Product Change Notice

(PCN tracking number: CST-R2-AH064 Rev.1.0) PC-M62-B002A/E July 24, 2018

Renesas Product Standard SRAM (TSOP) products.

Change Description: Change of lead frame type from etched to stamped for 44pin TSOP(II) products

Comparison (Inner lead shape)

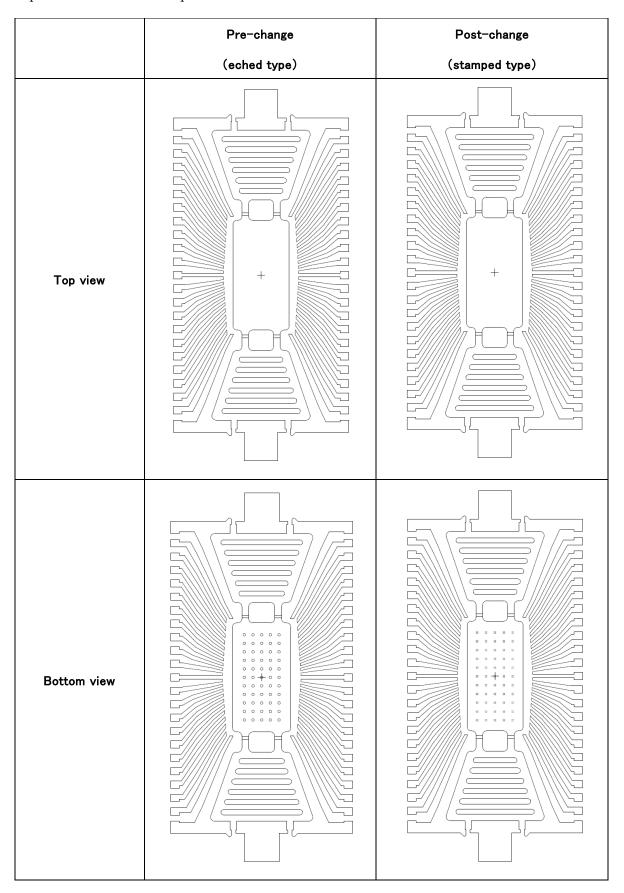
Lead frame type is changed from etched to stamped for standard SRAM 44pin TSOP(II) products assembled in Amkor Technology Malaysia.

Except lead frame type, there is no change in the external form, fit of package, base metal of lead frame and electrical functionality. This leads to unchanged quality and reliability of the products. For the changed products, evaluation and reliability tests have been successfully done to prove there is no problem.

Inner lead shape is shown in the following figure for both before and after change.
